SUBJECT: Response to NRC Letter Dated October 29, 1982, on
Allegations Regarding Construction Quality at
San Onofre Nuclear Generating Station, Units 2 & 3

Subject: San Onofre Nuclear Generating Station, Units 2 & 3
Bechtel Job 10079
Allegations Made by Mr. E. E. Kent

TYPE C

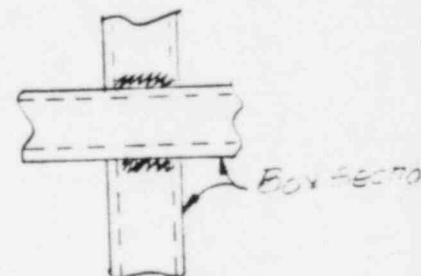
In Detail C, Mr. Kent contends that the weld detail is inadequate and should be welded all around. This interpretation is not only highly subjective but in clear violation of the AWS Code §8.8.5. This section clearly prohibits an orthogonal weld detail fillet welded, which is welded from two independent directional planes, from being welded continuously. This section requires that the weld be broken at the junction of the two welding planes. This shows the lack of understanding of specific and relevant code provisions by Mr. Kent. In the application of the detail, the weld has been conservatively sized to maintain weld stresses considerably below allowables and the design meets the design criteria for the project. Here again the weld end interpretation by Mr. Kent is in error and clearly violates the specific provision of the AWS Code.
